2301 Granville St (COMPLETE APPLICATION)
DP-2017-01278 - C3-A

DEVELOPMENT PERMIT STAFF COMMITTEE MEMBERS

DEVELOPMENT PERMIT STAFF COMMITTEE RECOMMENDATION: APPROVE

Figure 19. Maximum Heights

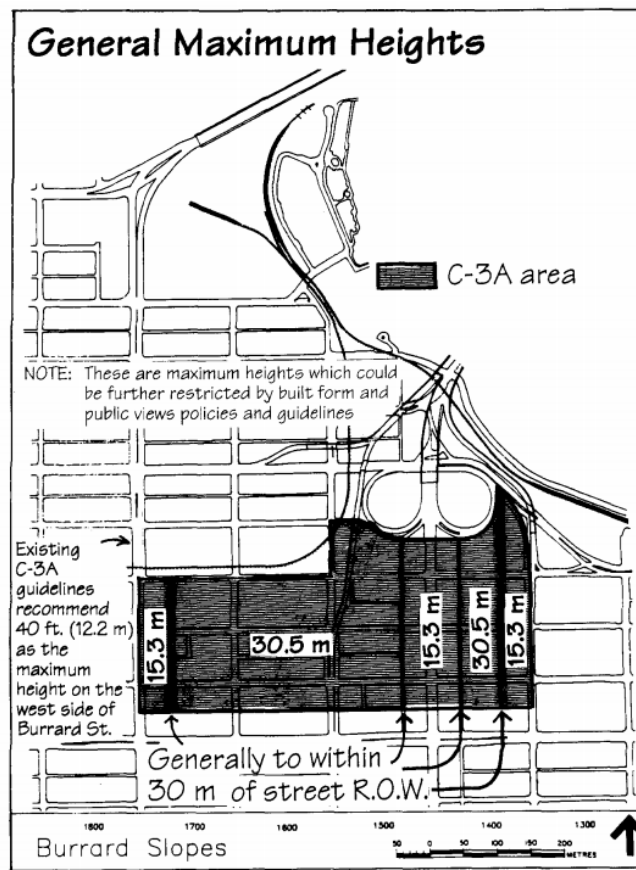
Figure 19 - General Maximum Heights (at right) of the Burrard Slopes C-3A Guidelines defines the intended maximum street enclosure for views north on Granville St. In addition, View Cone 20, originating at the intersection of Granville and W. Broadway, nominally aligns with the general 30m height limit from the Granville R.O.W. as noted.

This proposal is generally in keeping with the guidelines for height including transitioning from a maximum of 7.5m (24.7ft) at the Granville frontage to 26.13m (85.73ft) outside of the line established by View Cone 20.
